CTC & AAC BP08 Fit Out group 2

ADDENDUM #2

Addendum #02 BP-08 (Group 2)

Client	University of Kentucky Healthcare	Date	5/6/25
Project	UK Cancer Center + AAC BP-08 Fit-Out (Group 2) ADD#2	UK Project #	2563.3
	UK-2563.30-16-25	Champlin Project #	514-6926

A610

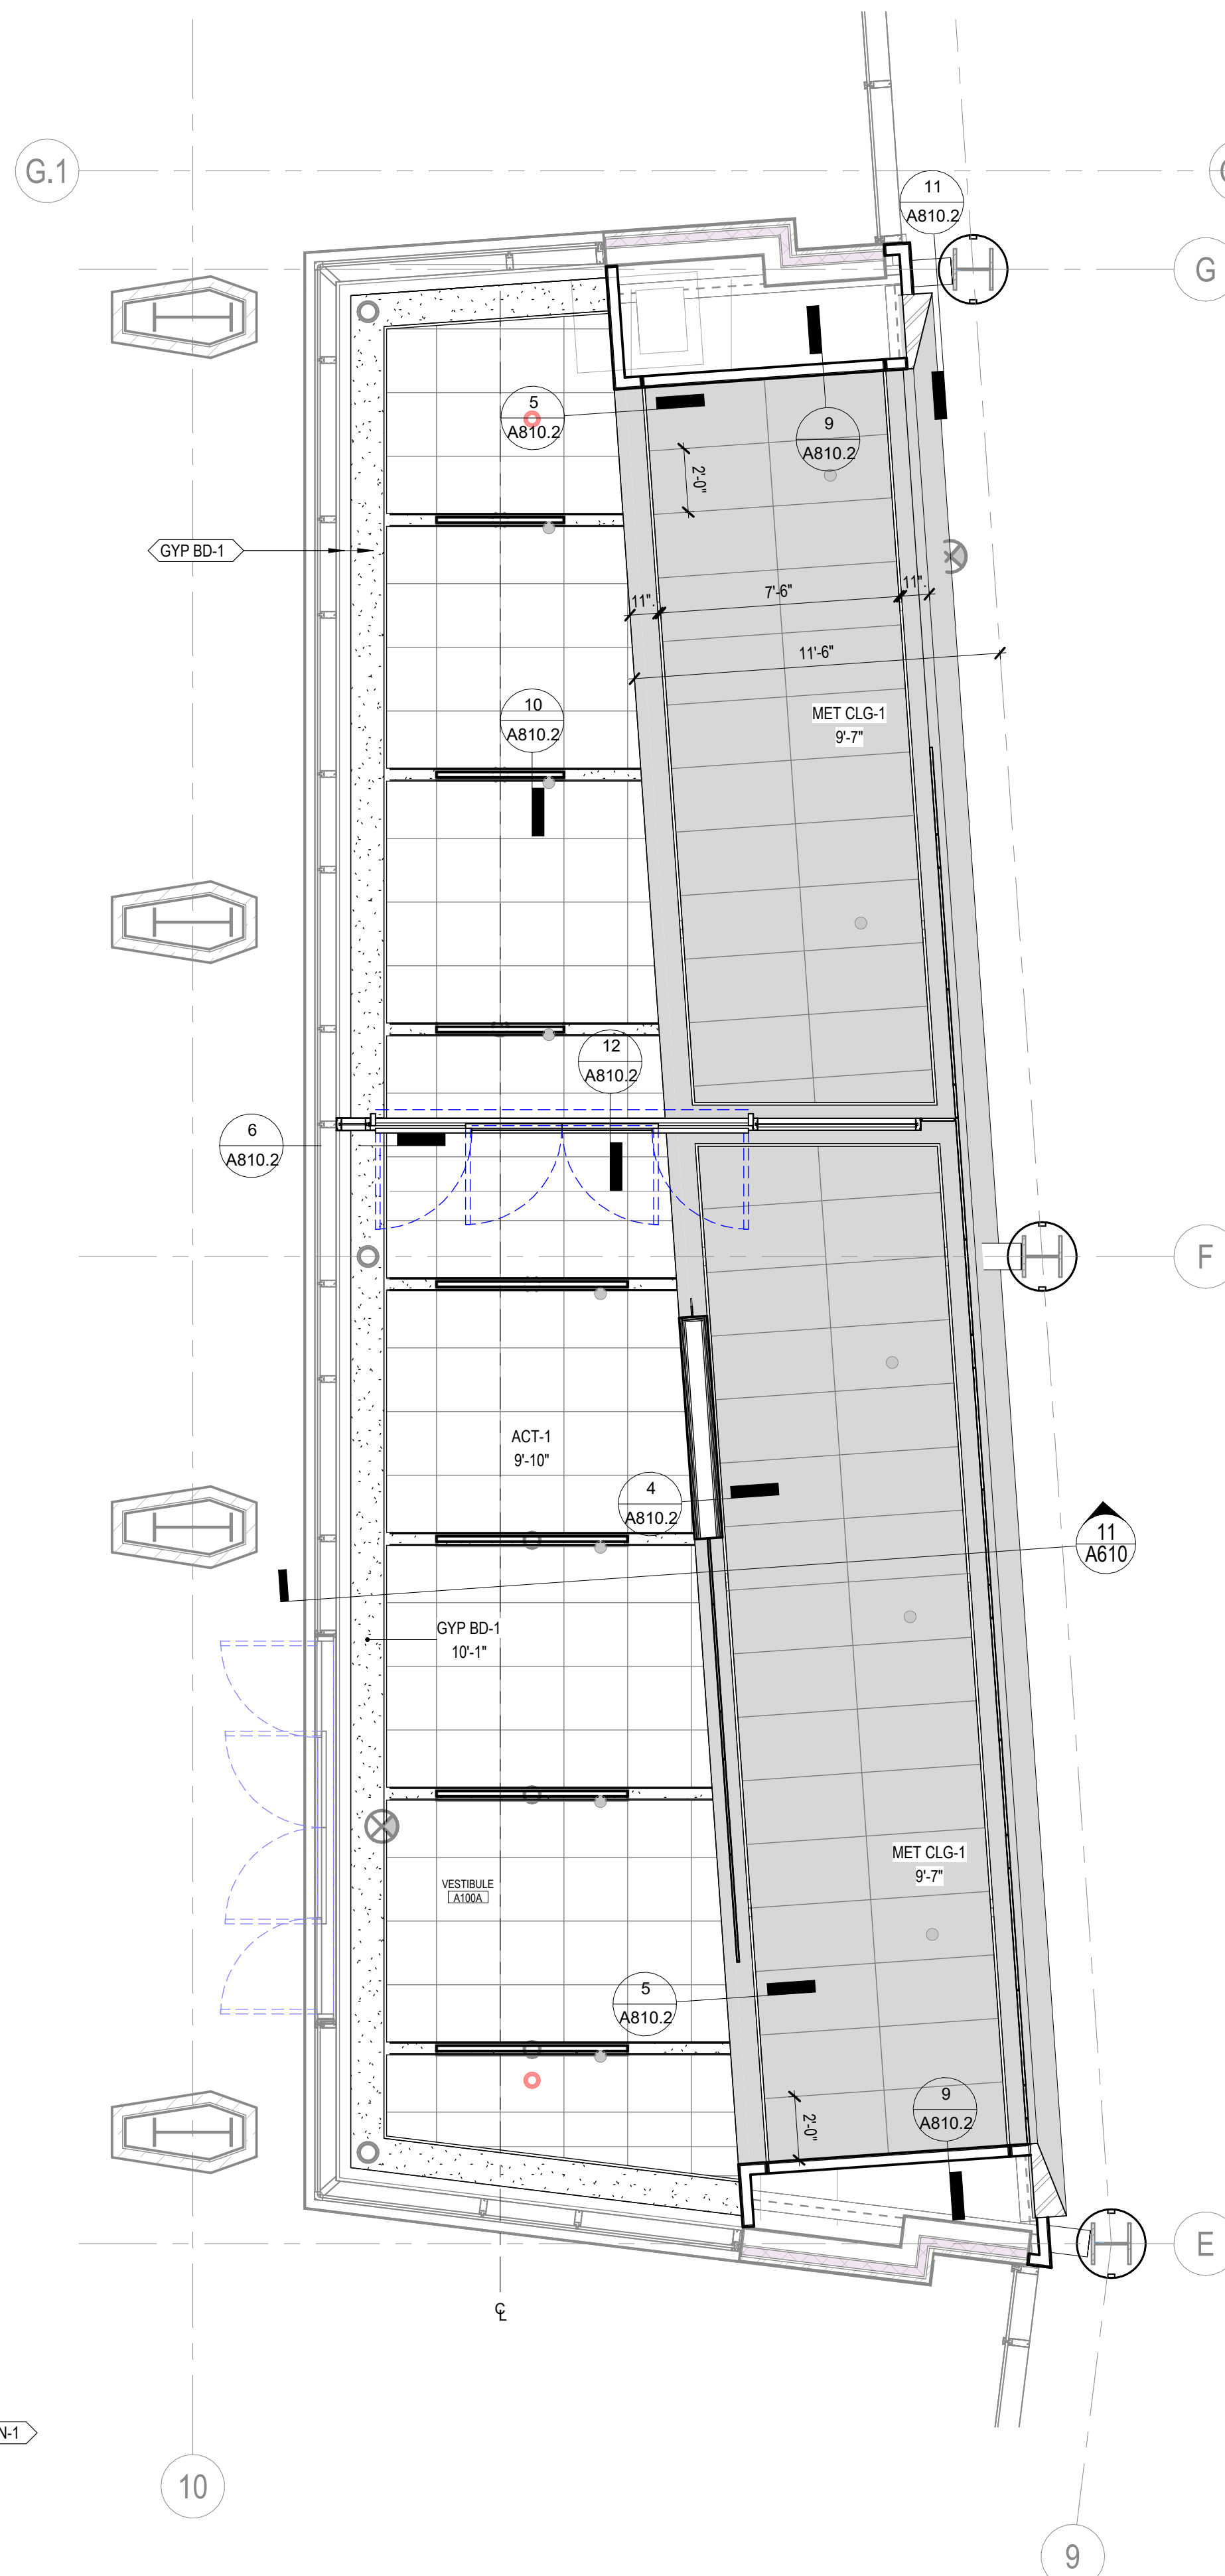
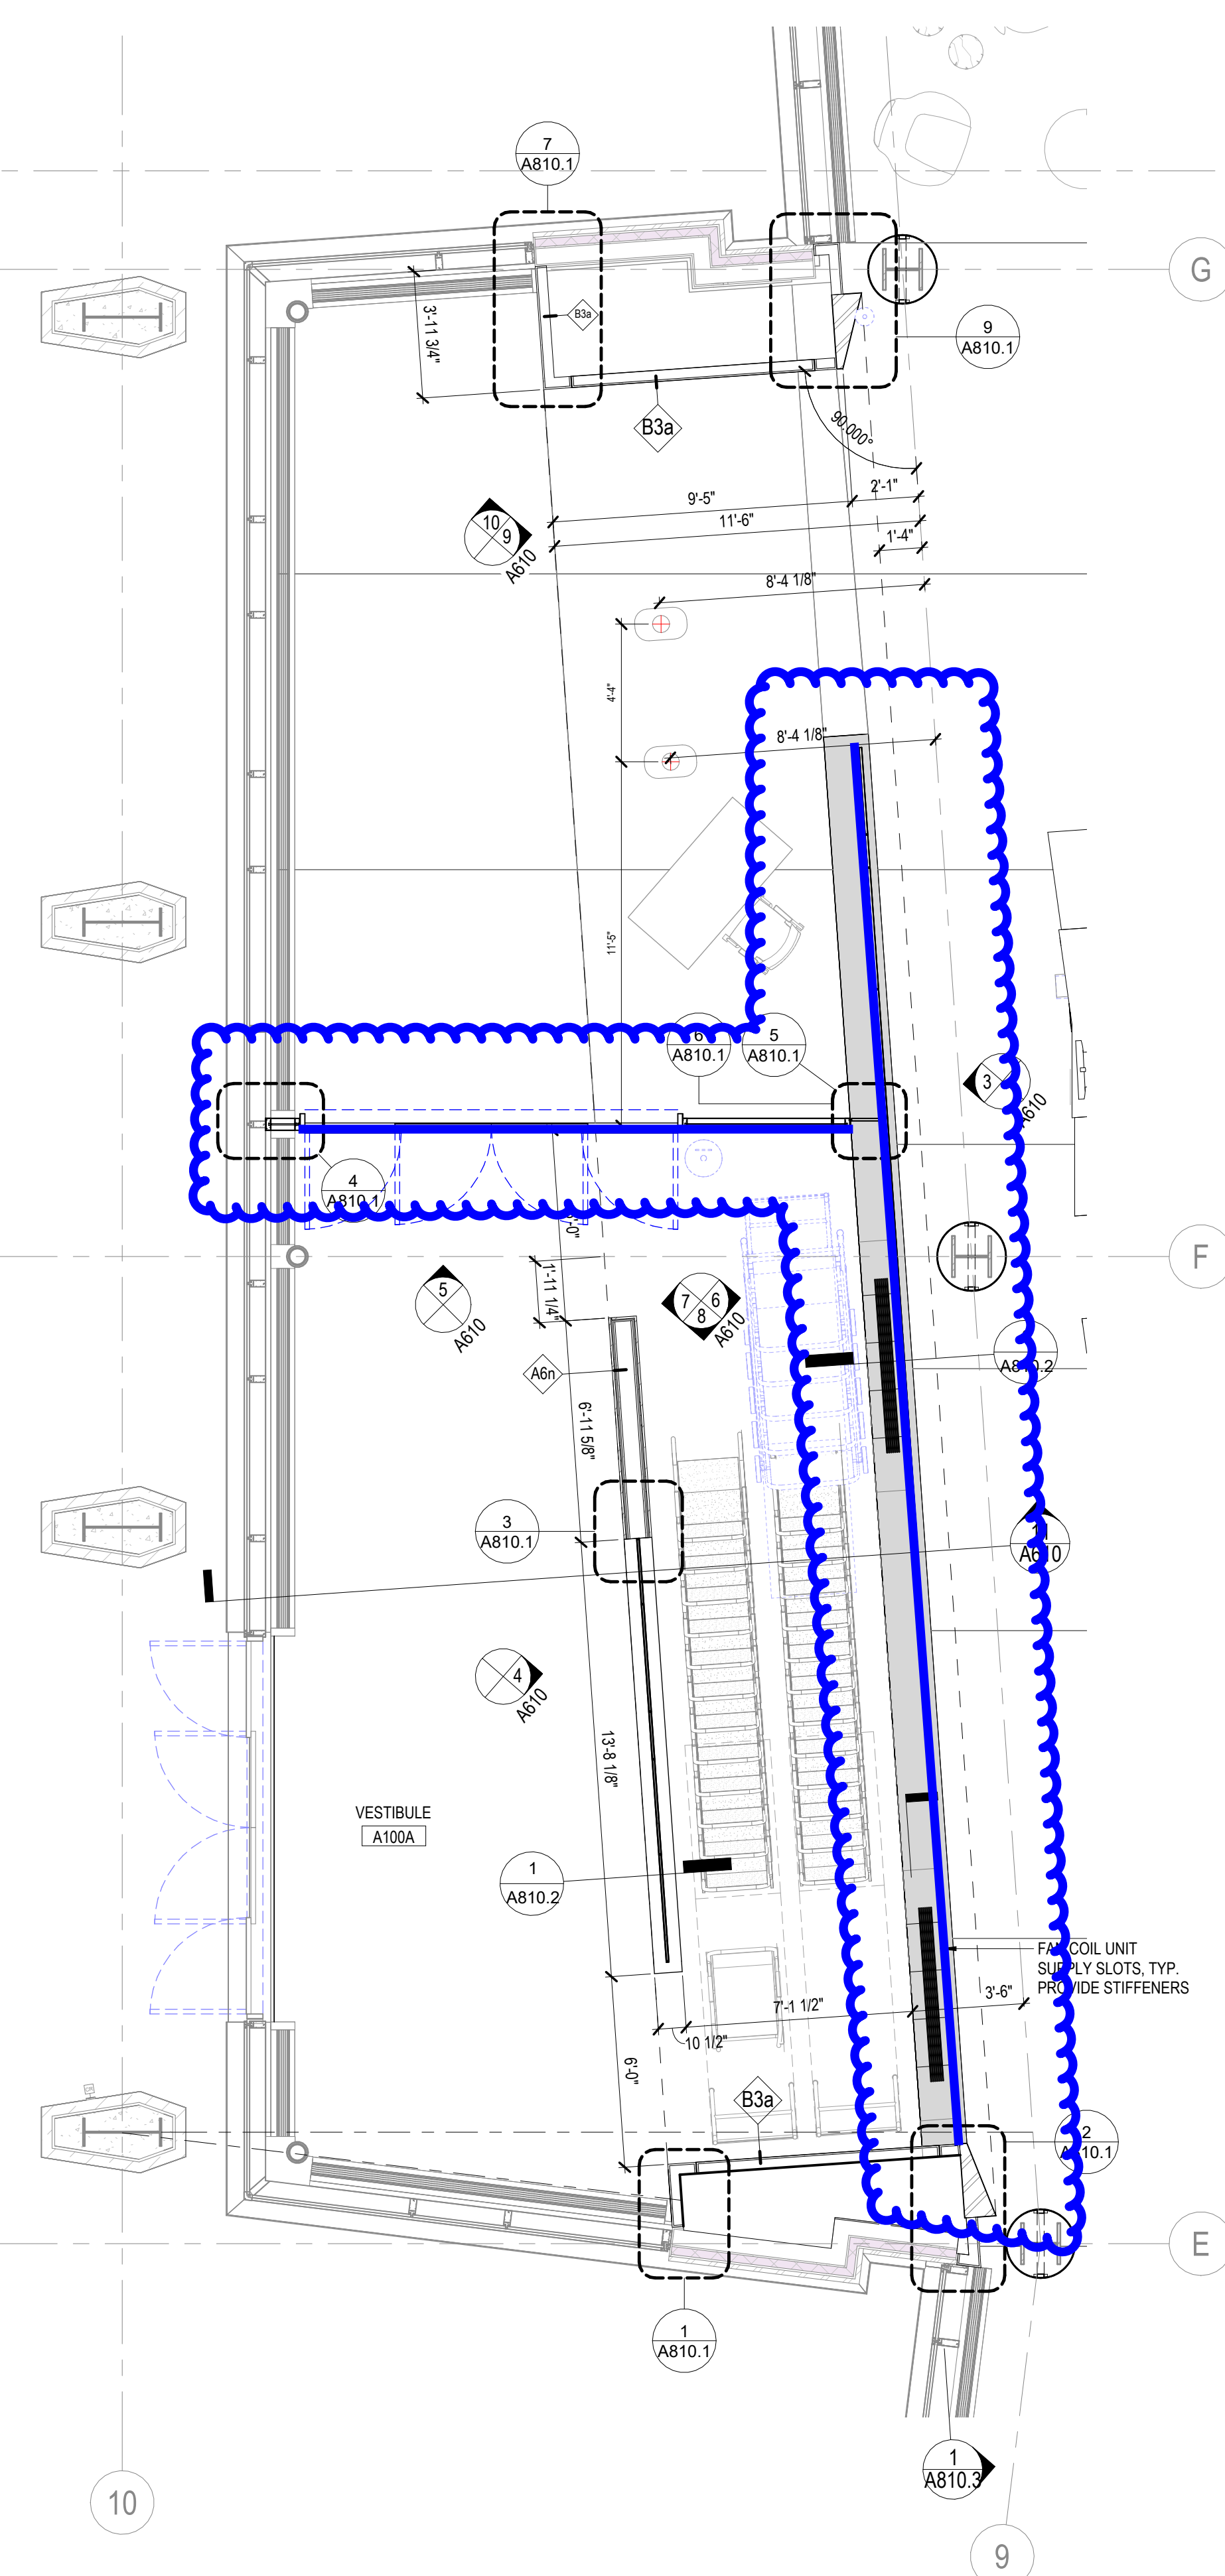
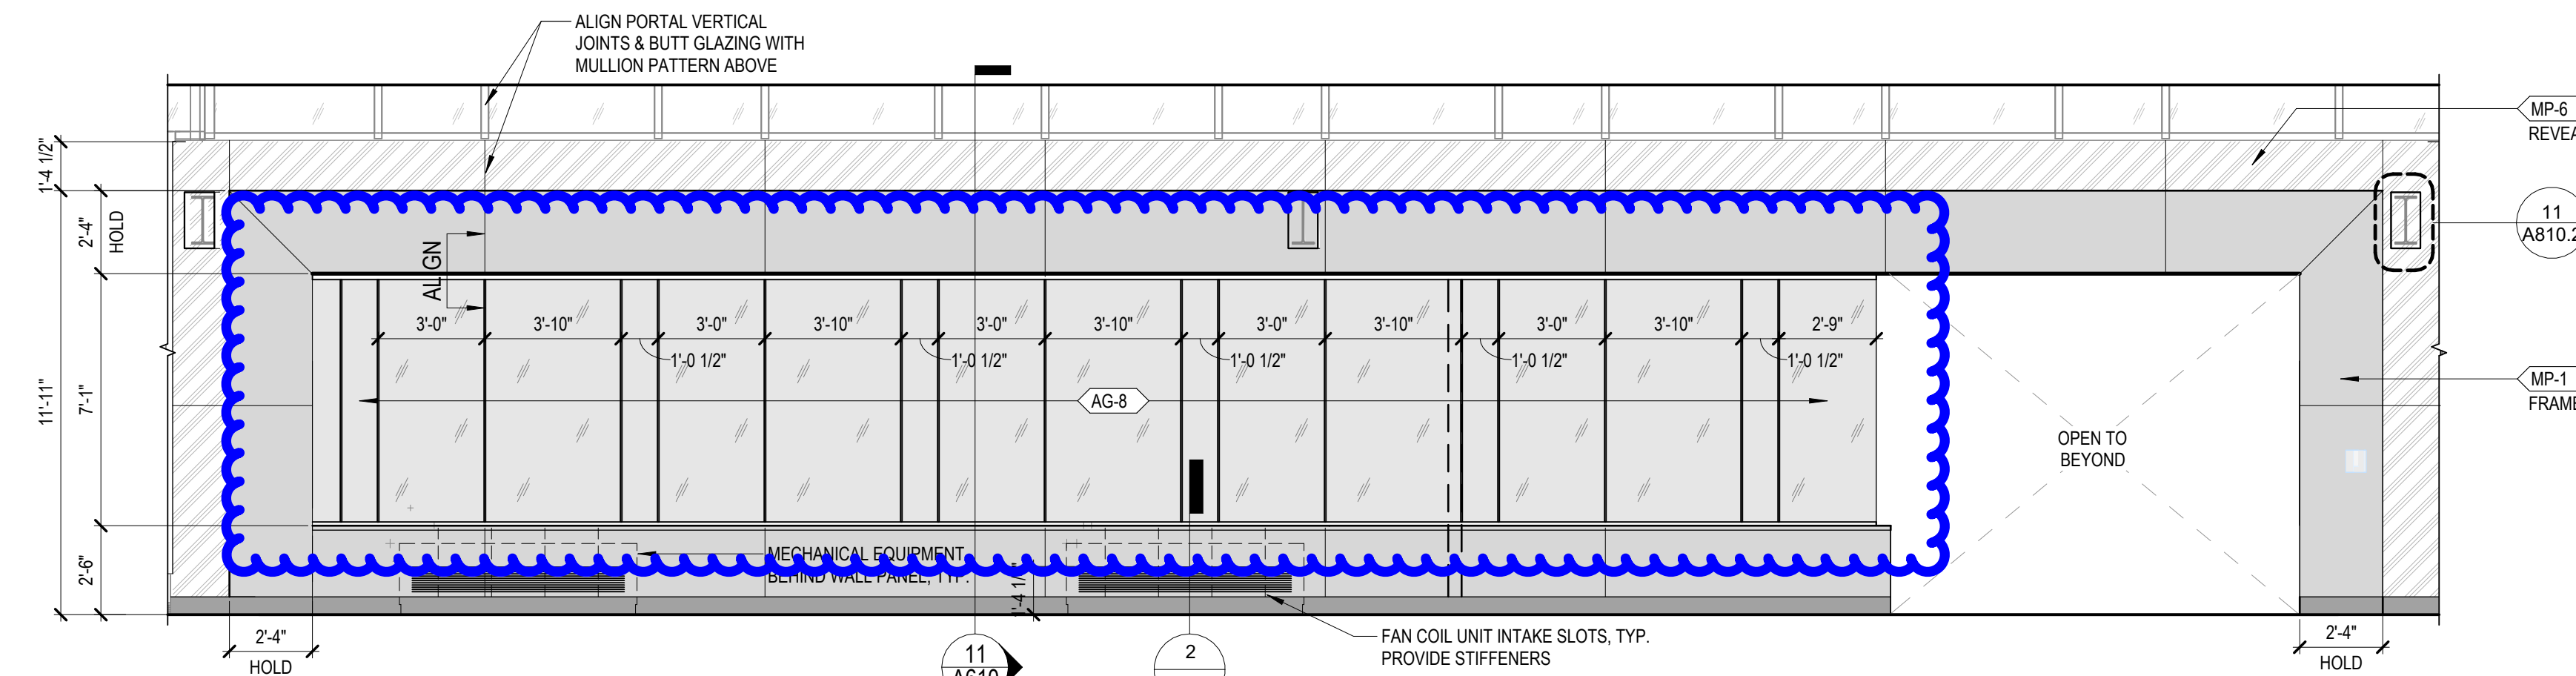
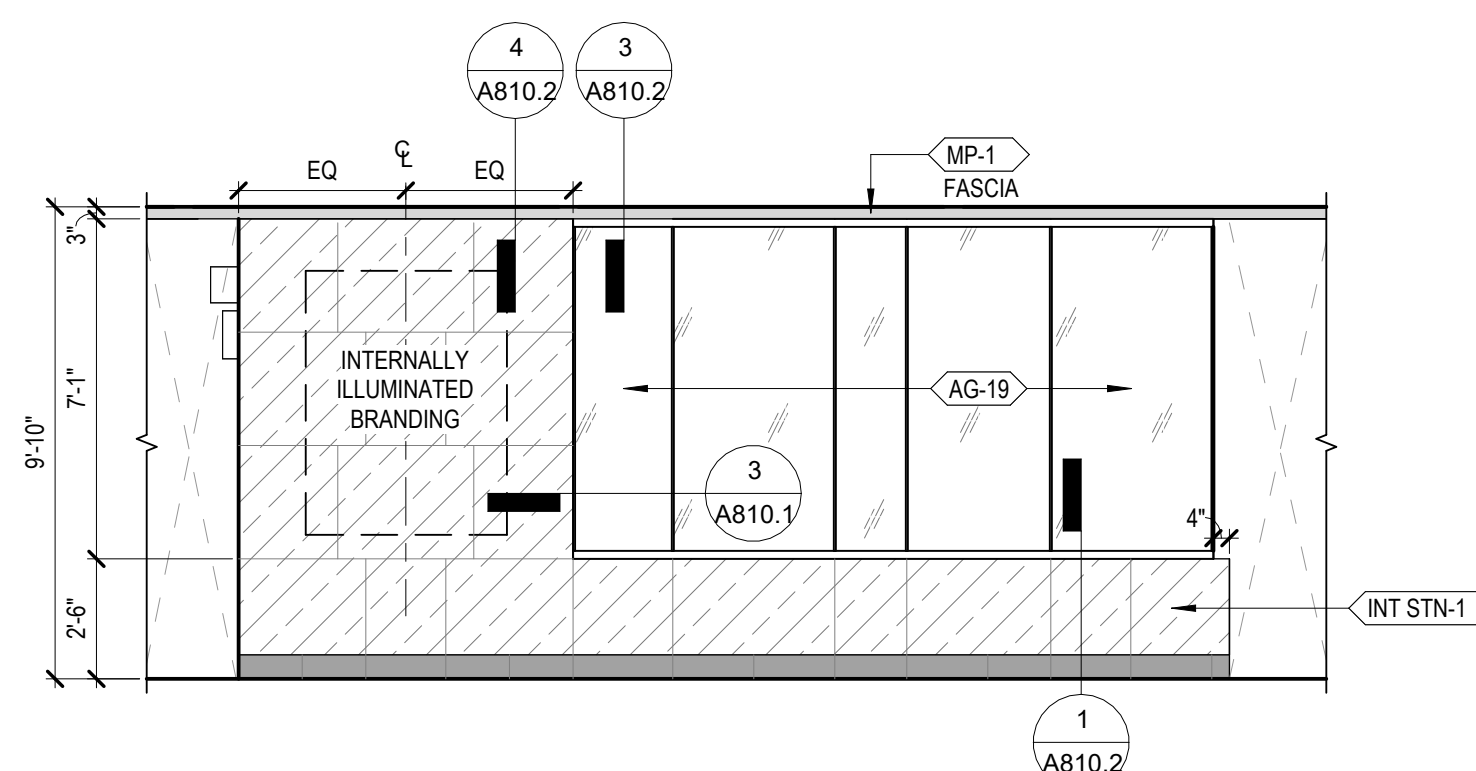
154	Confirming the PLGL-1 dividers are not a part of the interior glazing scope. See 4 and 6/A609.1 for example.	Walsh	PLGL-1 Dividers to be provided by the Finish Carpentry subcontractor	
155	Confirm glass type requirement at door opening A104.	Champlin	A104 Meditation Room - Sidelight is GL-4 Frosted Meditation Blue	
156	Confirm glass type requirement at door opening A108C	Champlin	A108C Office Manager - Frosted GL-20	
157	Confirm frame configuration at opening A100W3. The door schedule says HM-002 which has no sidelites or transoms. The floor plans and elevations show sidelites and transom.	Champlin	A100W3 Waiting Room - Wood Framed Glazing System	
158	Is the interior glazing contractor to include ASLD-1 auto entrances at openings A100A.2 and C100A.2?	Walsh	Interior Glazing Subcontractor shall include in their bid a fixed value allowance for work at A100A.2 and C100A.2. Additionally, AG-8 Glass that is intended to match custom color curtain wall to be included in the same allowance. Refer to sketch included with this addendum.
